Access Compliance Report

Public Rights-of-Way

(Curb Ramps)

Intersection ID: 29391	Main Street: FIREFLY_LN	Cross Street: GOLD_PAN_RD	Location:	N
ADA ID: 72BD932A5533	Ramp Type: PerpDiag	Initial Pass/Fail: Fail	Overall Compliance: No	Severity Score: 33.75
Codes/Mitigation Info/Possible Solution		Field Measurements/Component Compliance

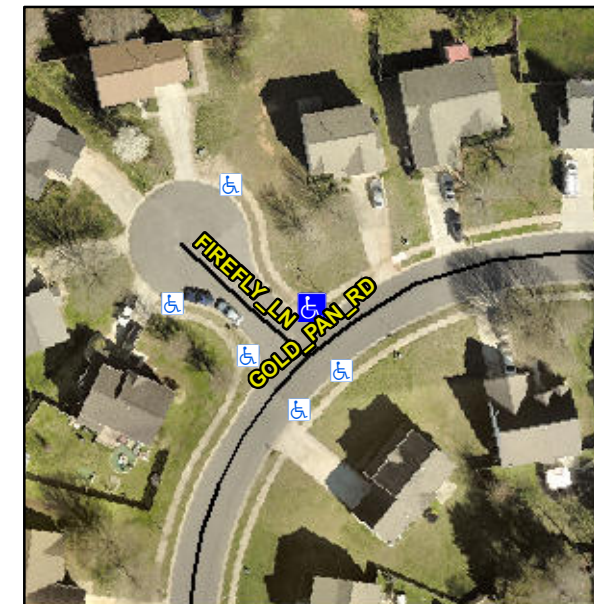
Not Found, R304.5.1, R304.2.2, R304.5.3

Compliance	Description	Data	Compliance	Description	Data
N/A	Ramp Length (in)	48.5	No	Ramp Slope (%)	8.7
No	Ramp Width (in)	47.0	No	Ramp XSlope (%)	5.4
N/A	Flare Type LT	N/A	N/A	Flare Type RT	N/A
N/A	Flare Slope LT (%)	N/A	N/A	Flare Slope RT (%)	N/A
N/A	Flare Traversable LT?	N/A	N/A	Flare Traversable RT?	N/A
N/A	Landing Length (in)	N/A	N/A	DWS Provided?	N/A
N/A	Landing Width (in)	N/A	N/A	DWS Contrast?	N/A
N/A	Landing Slope (%)	N/A	N/A	DWS Length (in)	N/A
N/A	Landing X Slope (%)	N/A	N/A	DWS Full Width?	N/A
N/A	Landing Curb? (Y/N)	N/A	N/A	DWS Offset (in)	N/A
N/A	Shared Landing?	N/A			
N/A	Gutter Ponding?	N/A	N/A	Gutter Slope (%)	N/A
N/A	Gutter Lip Ht (in)	N/A	N/A	Gutter X Slope (%)	N/A
N/A	Painted X Walk1?	No	N/A	Painted X Walk2?	No
	X Walk 1 Direction	To SW		X Walk 2 Direction	To SE
N/A	X Walk 1 Width (in)	N/A	N/A	X Walk 2 Width (in)	N/A
	X Walk 1 Slope (%)	1.5		X Walk 2 Slope (%)	2.2
	X Walk 1 X Slope (%)	0.9		X Walk 2 X Slope (%)	3.4

N/A	Ramp inside XWalk1?	N/A	N/A	Ramp inside XWalk2?	N/A
	Road Slope (%)	6.5	N/A	Clear Space?	N/A
	Road X Slope (%)	0.8	N/A	Clear Space to XWalk (in)	N/A
N/A	Any Obstructions?	N/A	N/A	Storm Grate/Utility Hazard?	N/A
	Obstruction Type			Storm Grate/Utility Type	
		N/A			N/A
			Yes	Surface Condition? (G/P)	Good

Remove & Replace Curb Ramp With Two New Directional Ramps or Equivalent.
